HISTORIC AND DESIGN REVIEW COMMISSION

July 07, 2021

HDRC CASE NO: 2021-276
ADDRESS: 206 E LULLWOOD AVE
LEGAL DESCRIPTION: NCB 6727 BLK 3 LOT 3&4
ZONING: RM-4, H
CITY COUNCIL DIST.: 1
DISTRICT: Monte Vista Historic District
APPLICANT: MORTON CHRISTOPHER J
OWNER: MORTON CHRISTOPHER J
TYPE OF WORK: Garage modifications, window replacement, Historic Tax Certification
APPLICATION RECEIVED: May 30, 2021
60-DAY REVIEW: Not applicable due to City Council Emergency Orders
CASE MANAGER: Rachel Rettaliata

A-4
4 OF 7

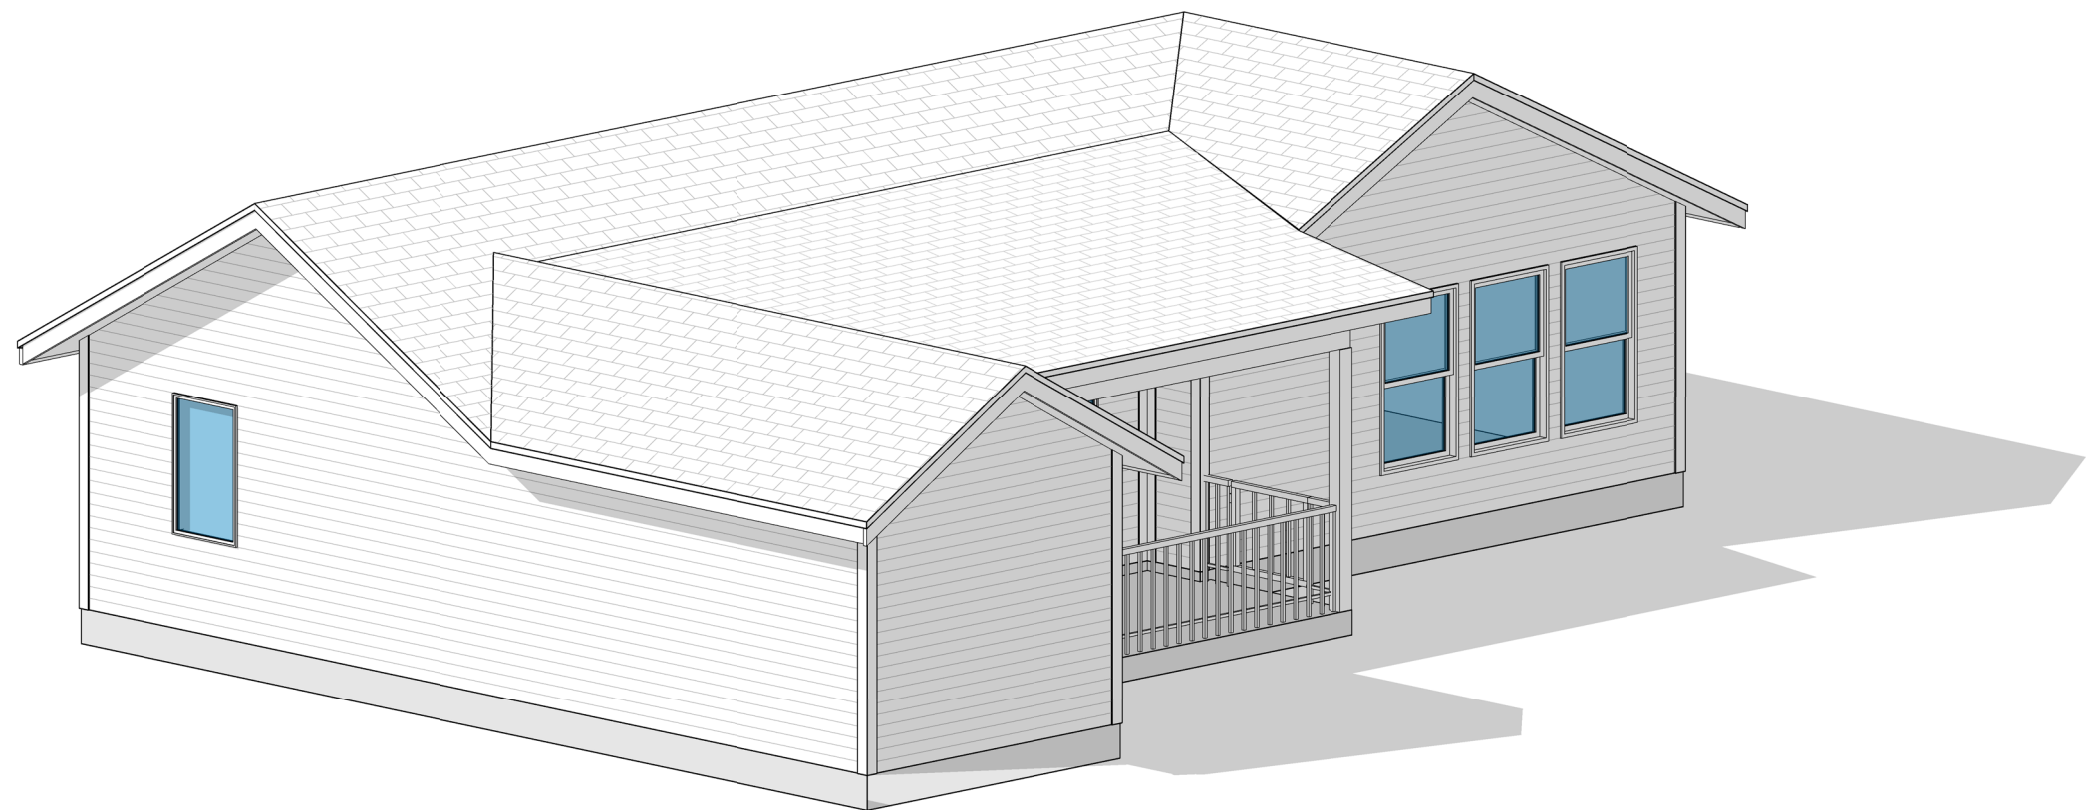
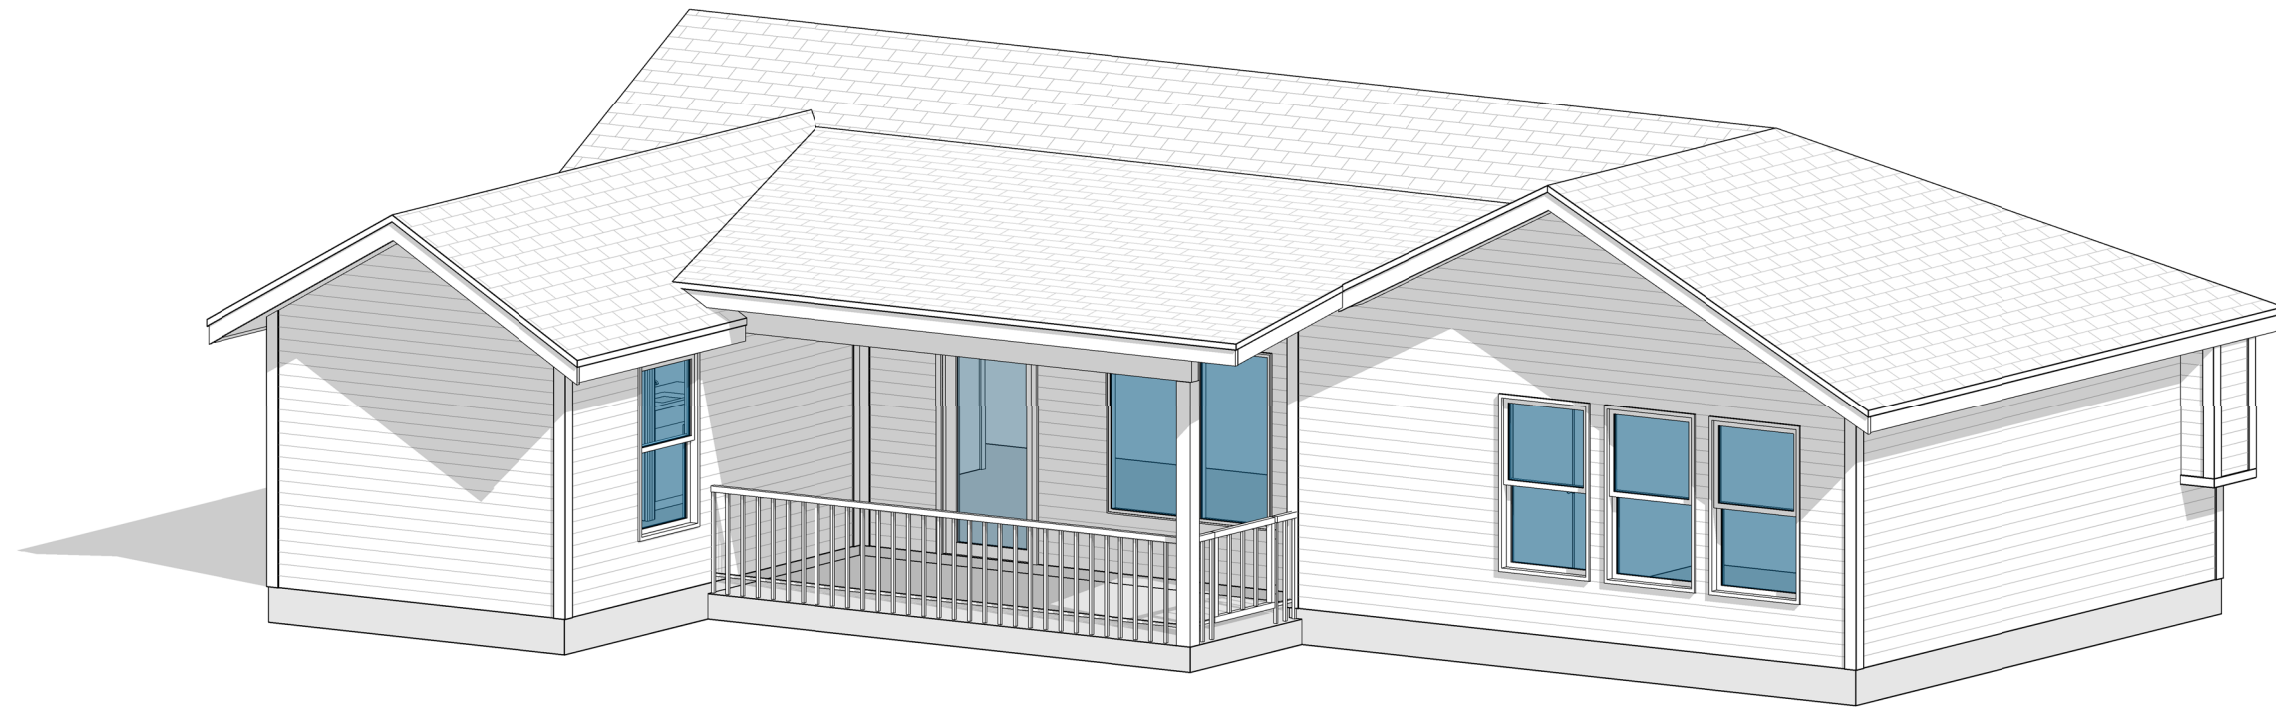
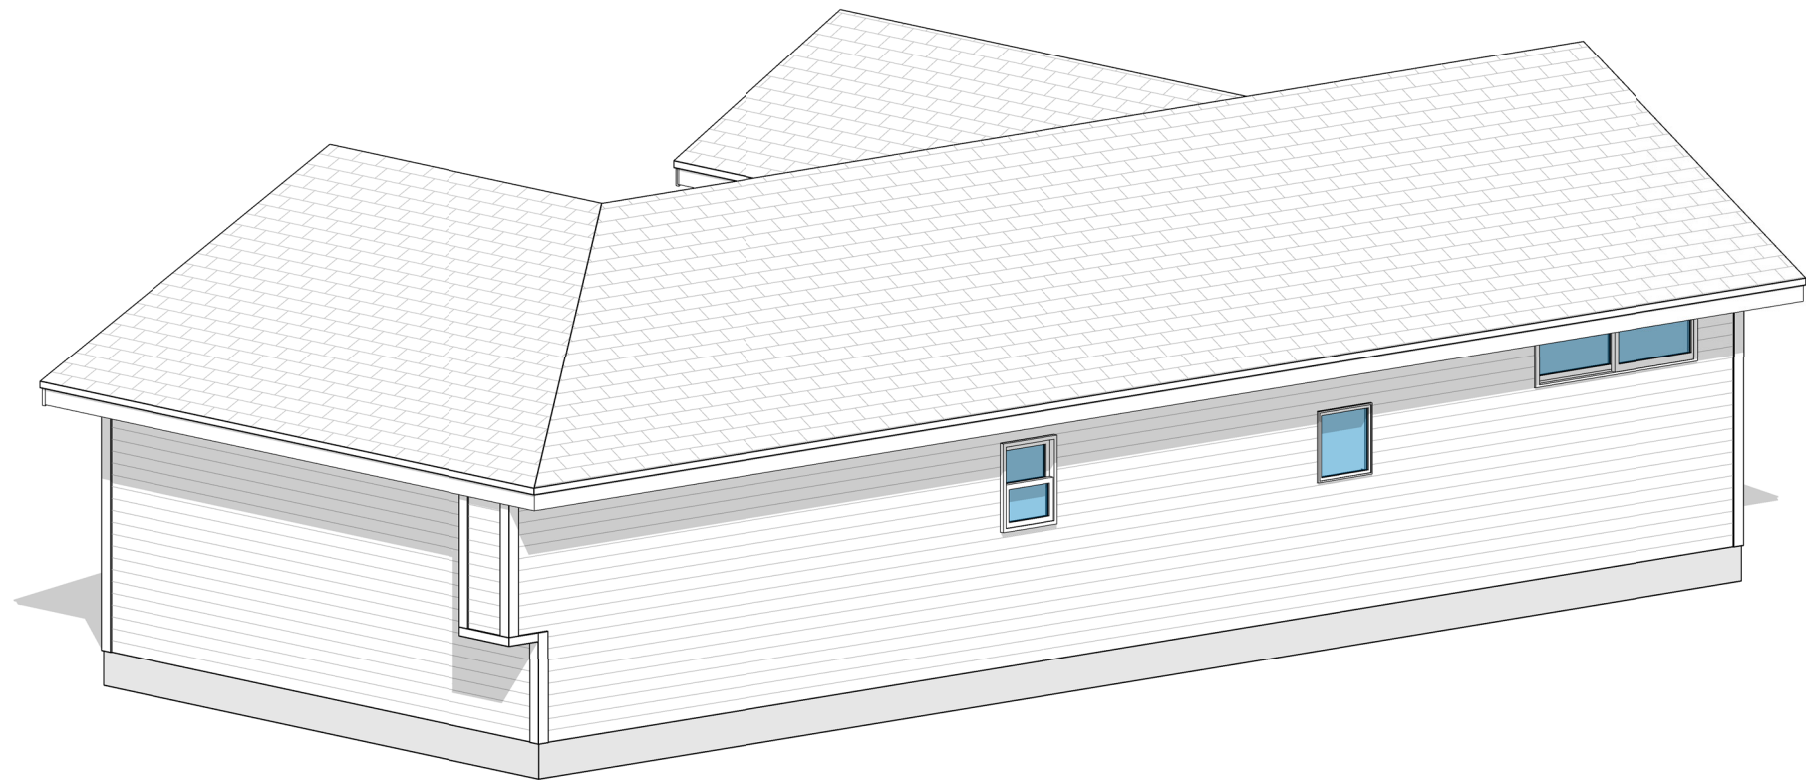
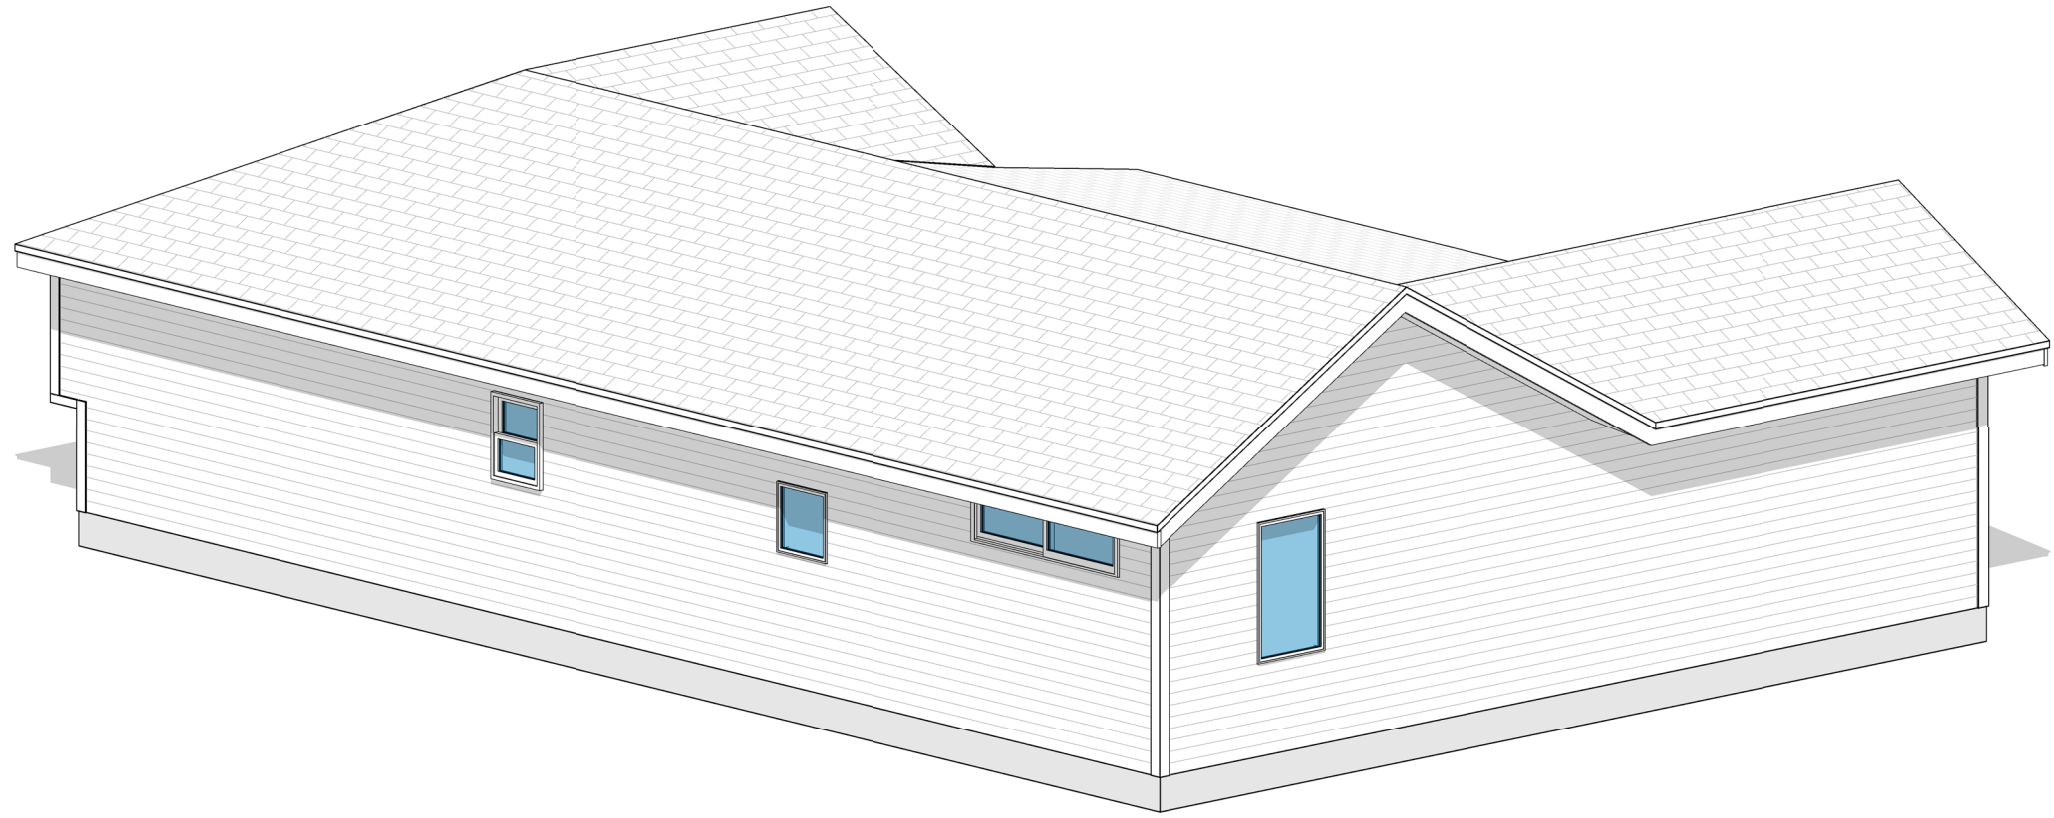
- c. GARAGE ENCLOSURE – The applicant has proposed to enclose the existing garage opening to convert the garage into an additional bedroom. The applicant has proposed to install 3 traditional sized one-over-one windows on the front façade garage enclosure and to install wood cladding to match the existing wood cladding beneath the shingle cladding. The applicant has proposed to install the PlyGem Aluminum windows in bronze at the garage enclosure. Guideline 6.A.i for Exterior Maintenance and Alterations states that existing window and door openings should be preserved. As the rear accessory structure is not visible from the public right-of-way and has likely been modified over time, staff finds the proposal appropriate.

- d. FENESTRATION MODIFICATIONS: WINDOW ENCLOSURE – The applicant has proposed to enclose the existing window openings on the rear elevation of the rear accessory structure. The rear elevation faces the property line and a rear privacy fence and is not visible from the public right-of-way. The rear elevation currently features 3 aluminum windows of nontraditional proportions. Guideline 6.A.i for Exterior Maintenance and Alterations states that existing window and door openings should be preserved. Staff finds that as the existing windows on the rear elevation are incompatible in material and size, are likely not original openings, and are not visible from the public right-of-way, the request is appropriate.

- e. FENESTRATION MODIFICATIONS: FRONT FACADE – The applicant has proposed to install 2 ganged PlyGem aluminum windows in bronze on the front façade next to the entry door. The existing façade features a single window next to the entry door. The proportions of each of the new ganged windows will match the existing. Guideline 6.A.i for Exterior maintenance and alterations states that existing window and door openings should be preserved. As the rear accessory structure is not visible from the public right-of-way and has likely been modified over time, staff finds the proposal appropriate.

Item 2, staff recommends approval of the garage enclosure based on finding c with the following stipulations:

- i. That the applicant submits final material specifications for the proposed cladding to staff for review and approval prior to the issuance of a Certificate of Appropriateness.

- ii. That the applicant installs windows that meet staff's standard window stipulations and submits updated specifications to staff for review and approval. The windows should feature an inset of two (2) inches within facades and should feature profiles that are found historically within the immediate vicinity. Meeting rails must be no taller than 1.25" and stiles no wider than 2.25". White manufacturer's color is not allowed, and color selection must be presented to staff. There should be a minimum of two inches in depth between the front face of the window trim and the front face of the top window sash. This must be accomplished by recessing the window sufficiently within the opening or with the installation of additional window trim to add thickness. Window trim must feature traditional dimensions and architecturally appropriate sill detail. Window track components must be painted to match the window trim or concealed by a wood window screen set within the opening.

Item 3, staff recommends approval of the window enclosure based on finding d with the following stipulation:

- i. That the applicant submits final material specifications for the proposed cladding to staff for review and approval prior to the issuance of a Certificate of Appropriateness.

Item 4, staff recommends approval of the fenestration modification based on finding e with the following stipulation:

- i. That the applicant installs windows that meet staff's standard window stipulations and submits updated specifications to staff for review and approval. The windows should feature an inset of two (2) inches within facades and should feature profiles that are found historically within the immediate vicinity. Meeting rails must be no taller than 1.25" and stiles no wider than 2.25". White manufacturer's color is not allowed, and color selection must be presented to staff. There should be a minimum of two inches in depth between the front face of the window trim and the front face of the top window sash. This must be accomplished by recessing the window sufficiently within the opening or with the installation of additional window trim to add thickness. Window trim must feature traditional dimensions and architecturally appropriate sill detail. Window track components must be painted to match the window trim or concealed by a wood window screen set within the opening.

Project: 206 E. Lullwood
Window for Consideration: Plygem 3710 Builder Series
Finish: Aluminum Bronze

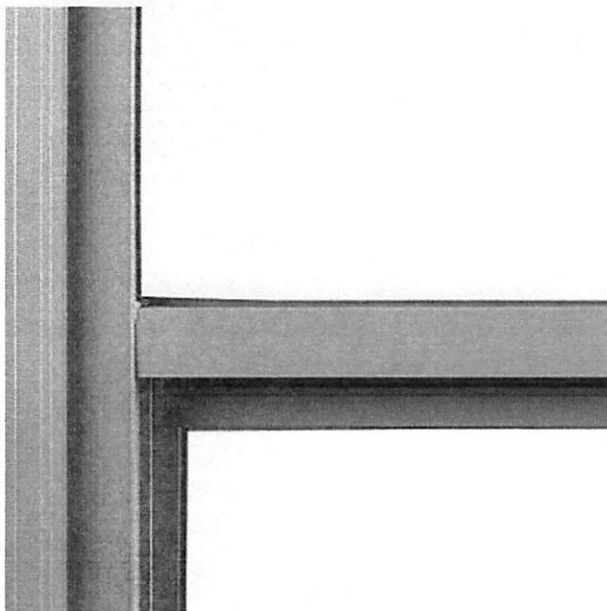
- b. WINDOW REPLACEMENT – The applicant has proposed to replace the existing aluminum windows on the rear accessory structure with PlyGem Aluminum windows in bronze that comply with staff's standard window stipulations. Guideline 6.B.vii for Exterior Maintenance and Alterations states that non-historic incompatible windows should be replaced with windows that are typical of the architectural style of the building. Staff finds that the proposed aluminum windows meet staff's standard window specifications and are an improvement to the structure. Staff finds the proposal appropriate.

Item 1, staff recommends approval of window replacement based on finding b with the following stipulation:

- i. That the applicant installs windows that meet staff's standard window stipulations and submits updated specifications to staff for review and approval. The windows should feature an inset of two (2) inches within facades and should feature profiles that are found historically within the immediate vicinity. Meeting rails must be no taller than 1.25" and stiles no wider than 2.25". White manufacturer's color is not allowed, and color selection must be presented to staff. There should be a minimum of two inches in depth between the front face of the window trim and the front face of the top window sash. This must be accomplished by recessing the window sufficiently within the opening or with the installation of additional window trim to add thickness. Window trim must feature traditional dimensions and architecturally appropriate sill detail. Window track components must be painted to match the window trim or concealed by a wood window screen set within the opening.
